STATE OF HAWAII
DEPARTMENT OF TRANSPORTATION
HIGHWAYS DIVISION

ADDENDUM NO. 2

**INTERSTATE ROUTE H-1 ADDITION AND MODIFICATION OF FREEWAY ACCESS
(KAPOLEI INTERCHANGE COMPLEX), PHASE 3**

FEDERAL-AID PROJECT NO. NH-H1-1(271)

SURVEY PLOTTED BY	DATE
DESIGNED BY	
TRACED BY	
QUANTITIES BY	
CHECKED BY

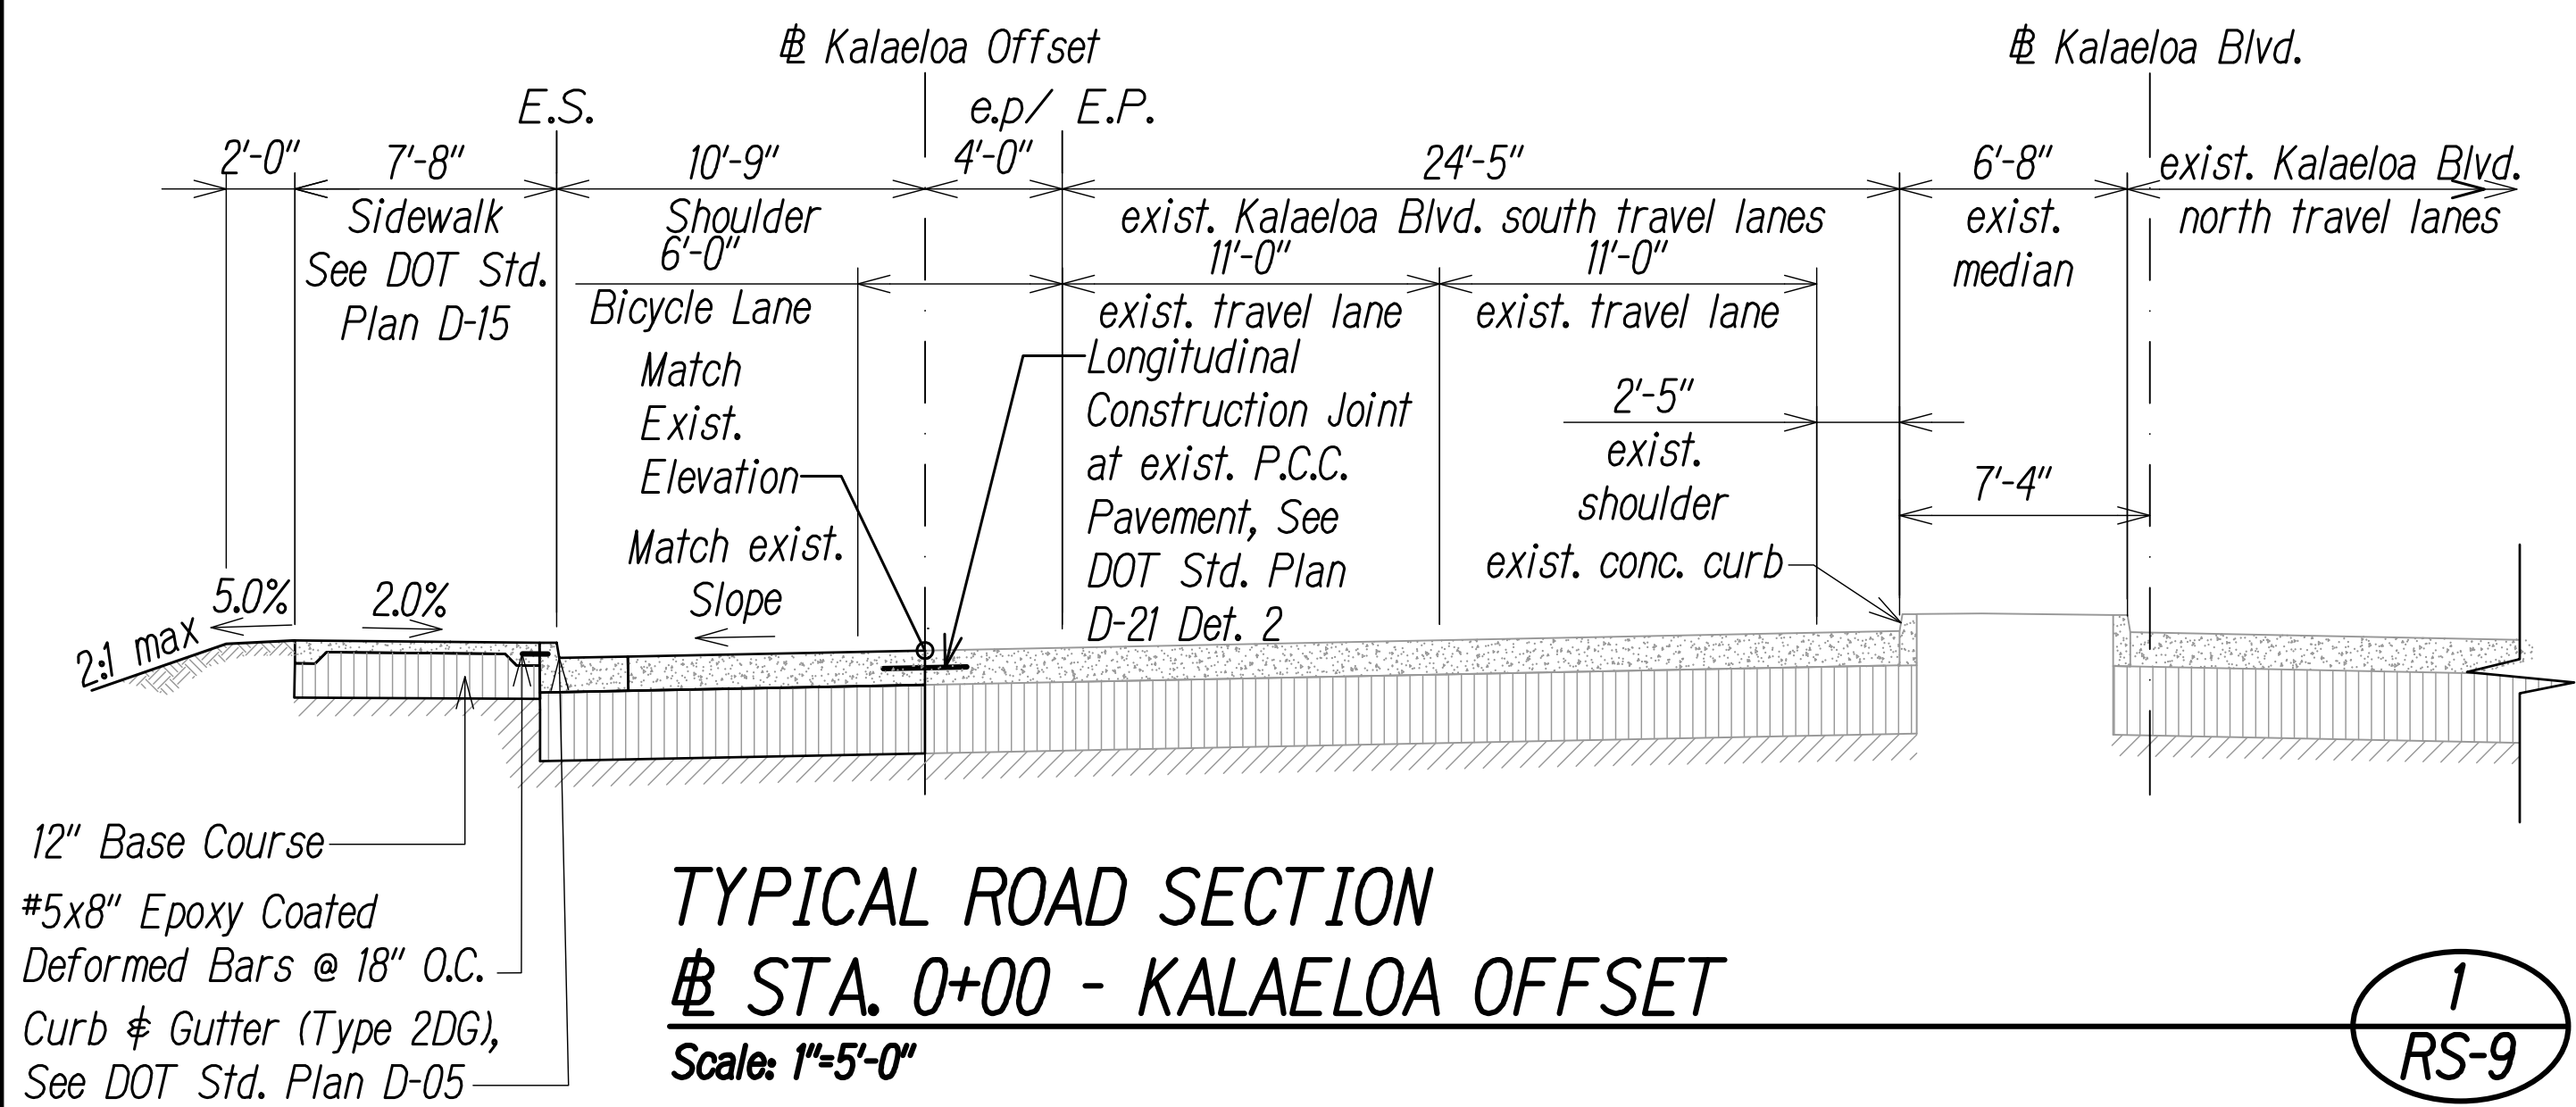
Added 6" Aggregate Subbase at guardrails	10/21/2022
REVISION	DATE
STATE OF HAWAII DEPARTMENT OF TRANSPORTATION HIGHWAYS DIVISION	
TYPICAL SECTIONS 9	
INTERSTATE ROUTE H-1 ADDITION AND MODIFICATION OF FREEWAY ACCESS (Kapolei Interchange Complex), Phase 3 Federal Aid Project No. NH-H1-K(271)	
Scale: As Noted	Date: August 2022

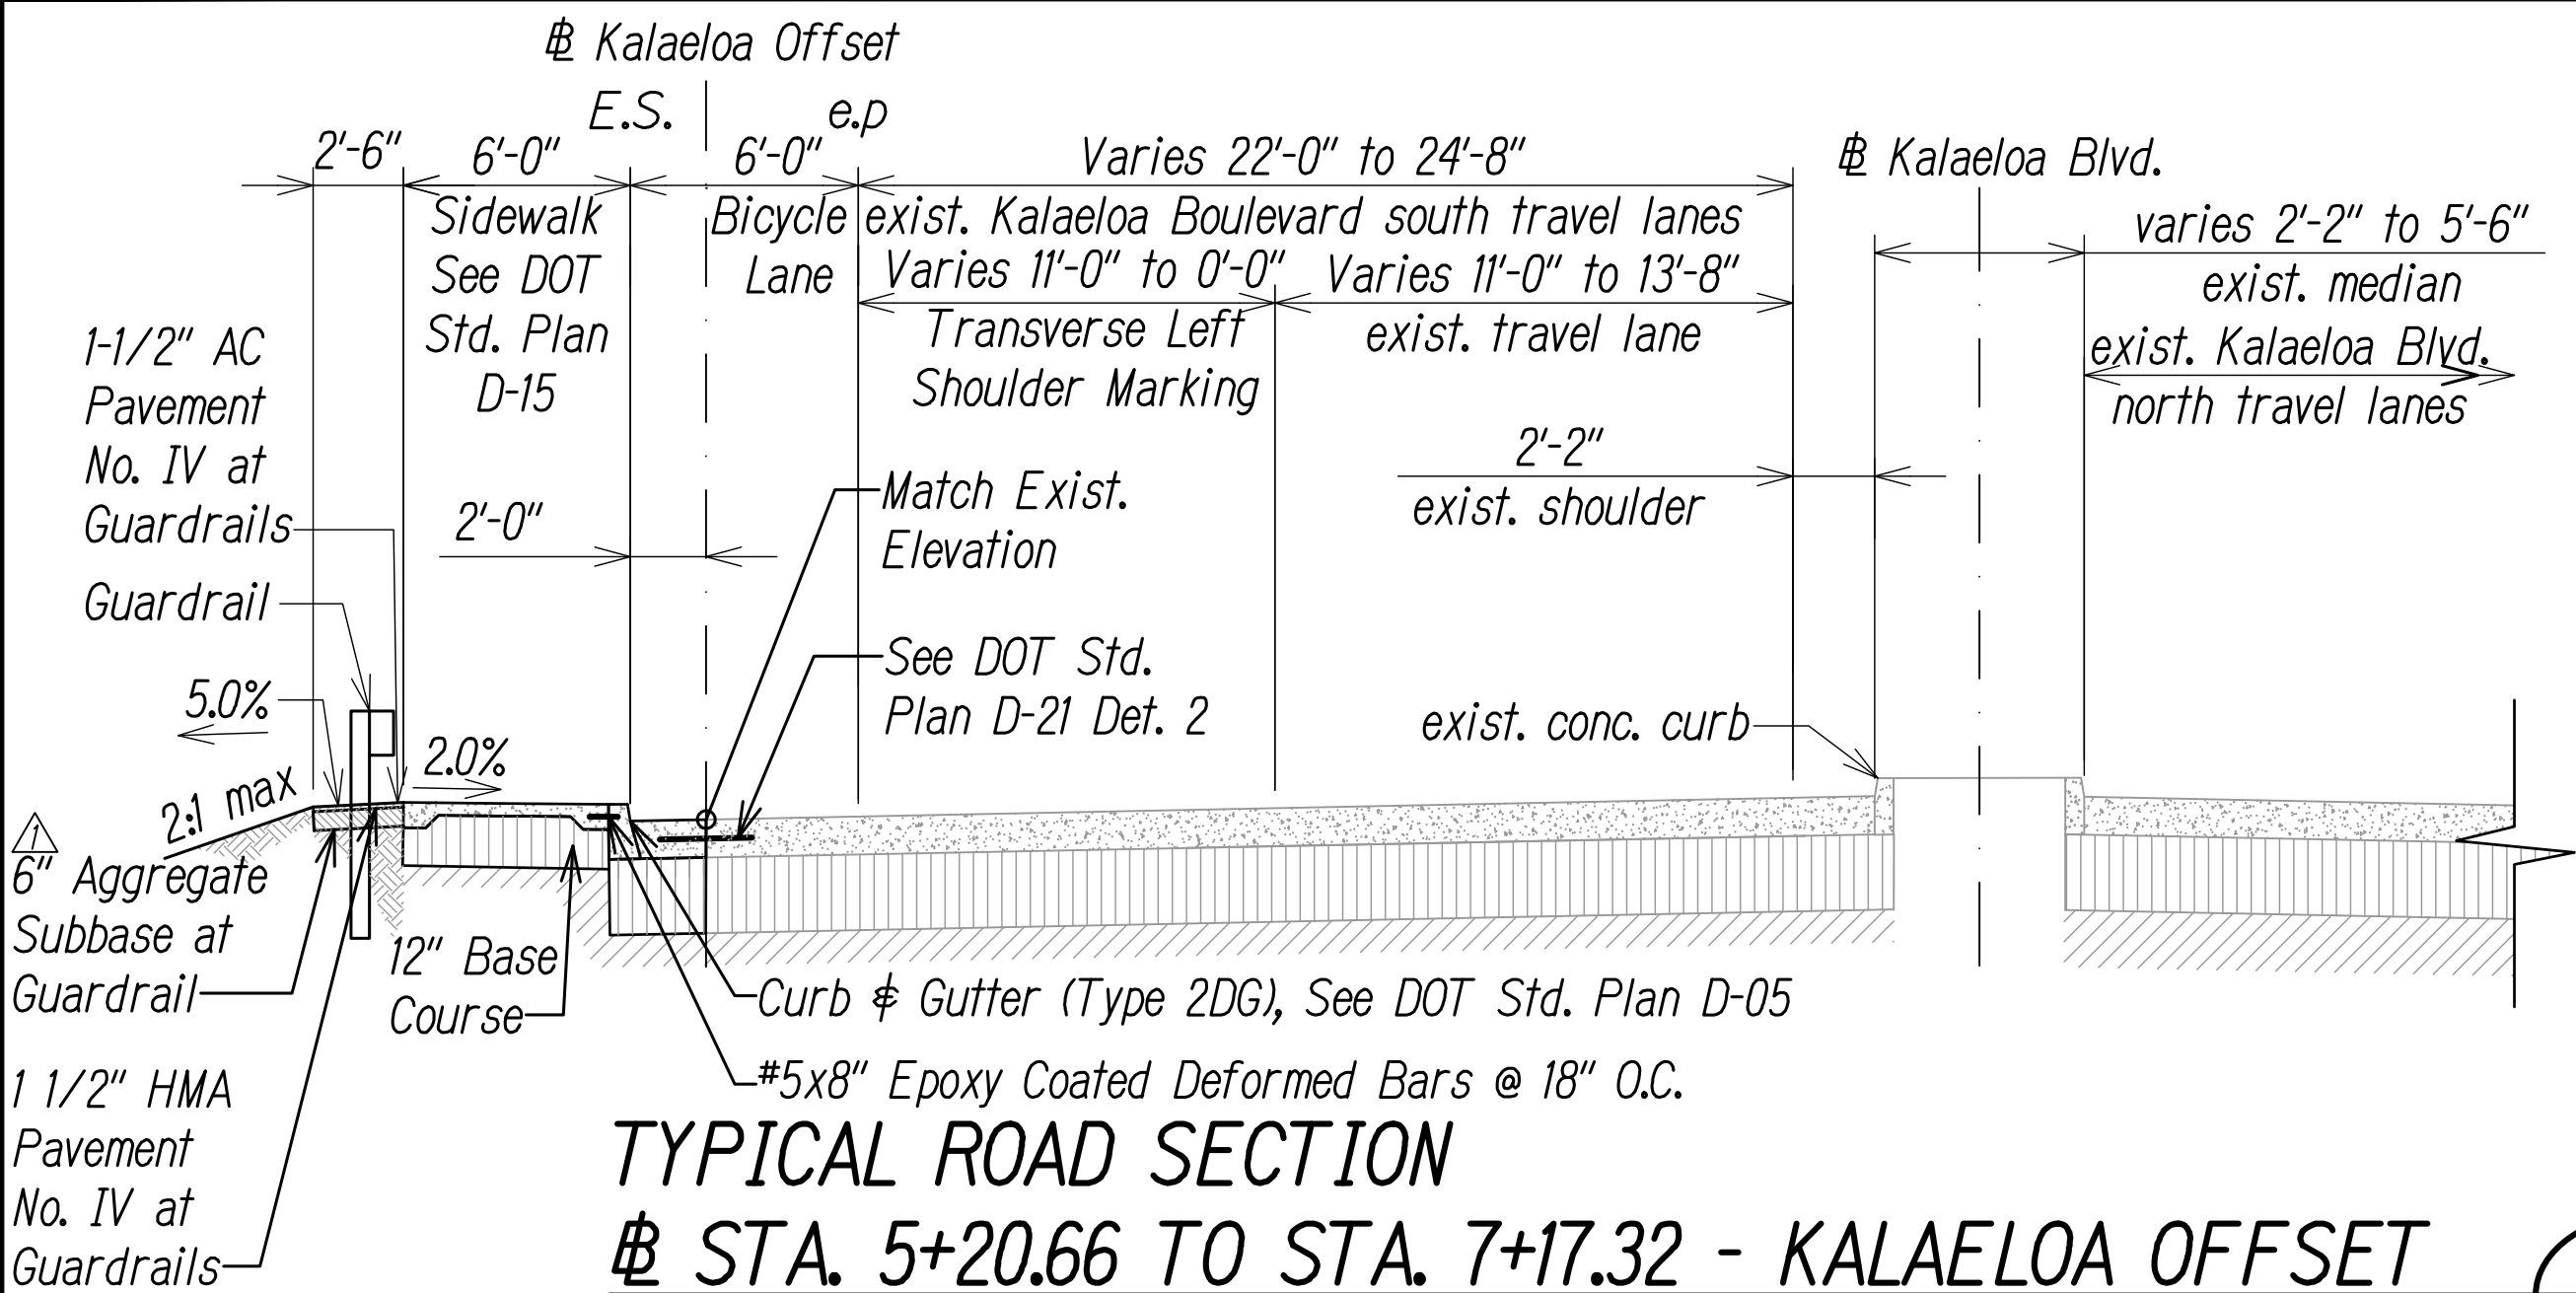
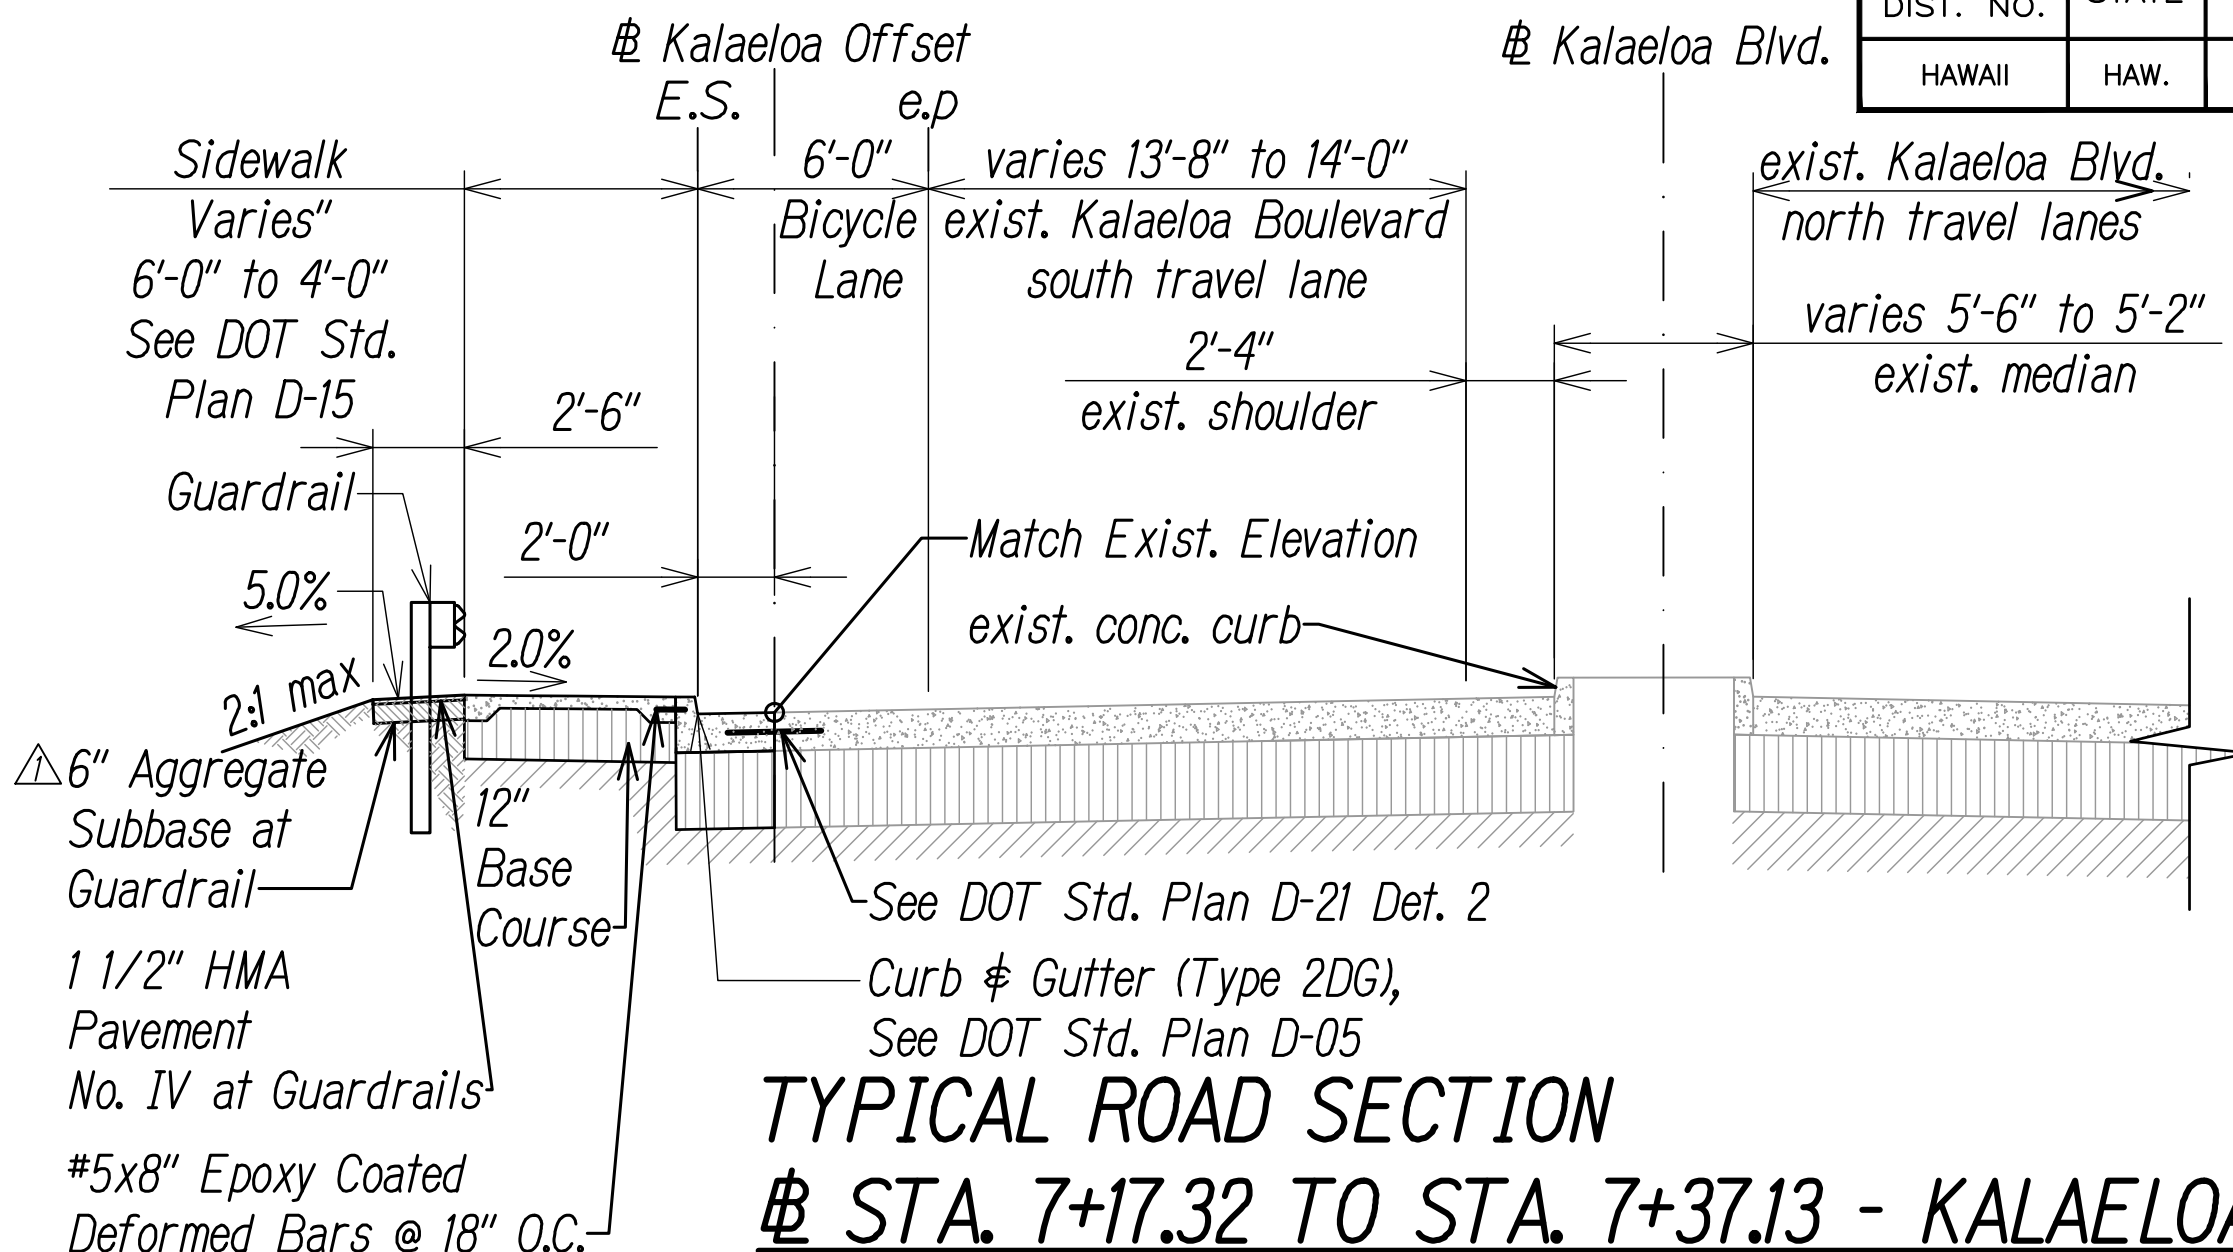
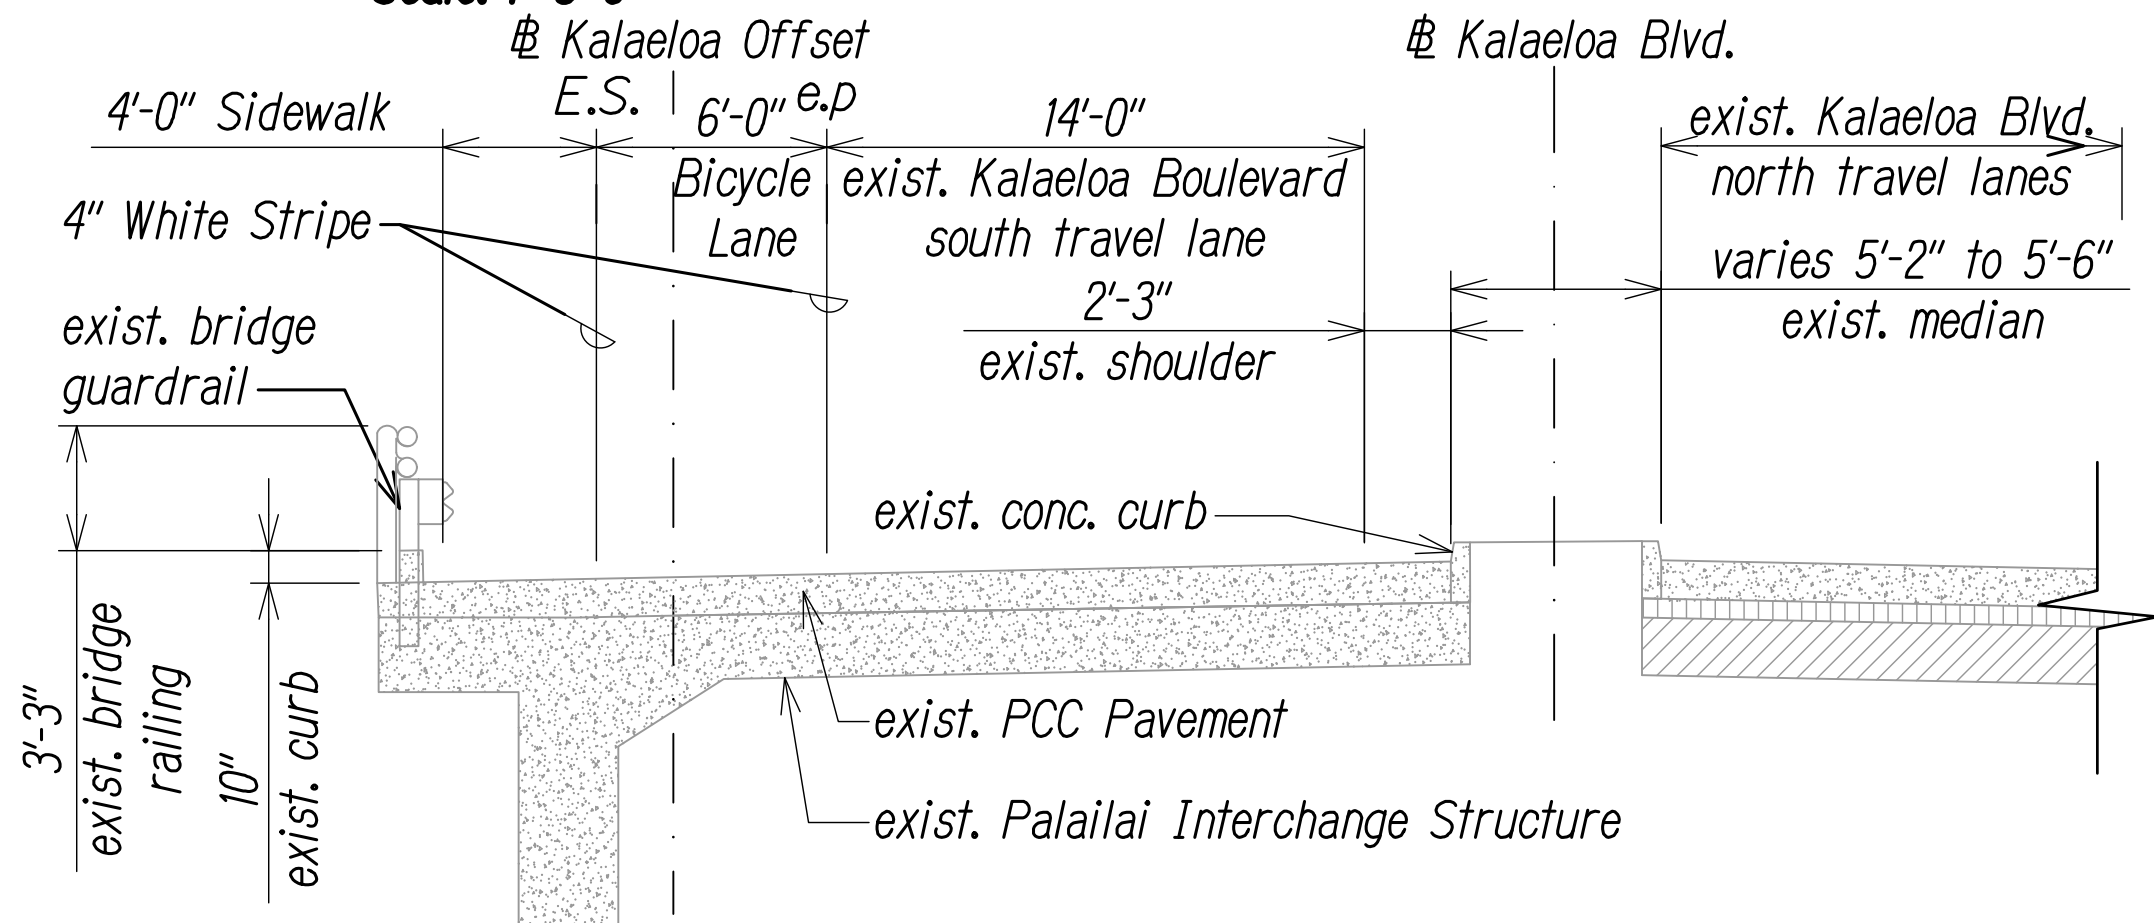
Added 6" Aggregate Subbase at guardrails	10/21/2022
REVISION	DATE
STATE OF HAWAII DEPARTMENT OF TRANSPORTATION HIGHWAYS DIVISION	
TYPICAL SECTIONS 10	
INTERSTATE ROUTE H-1 ADDITION AND MODIFICATION OF FREEWAY ACCESS (Kapolei Interchange Complex), Phase 3 Federal Aid Project No. NH-HI-K(271)	
Scale: As Noted	Date: August 2022
SHEET No. RS-10 OF 167 SHEETS
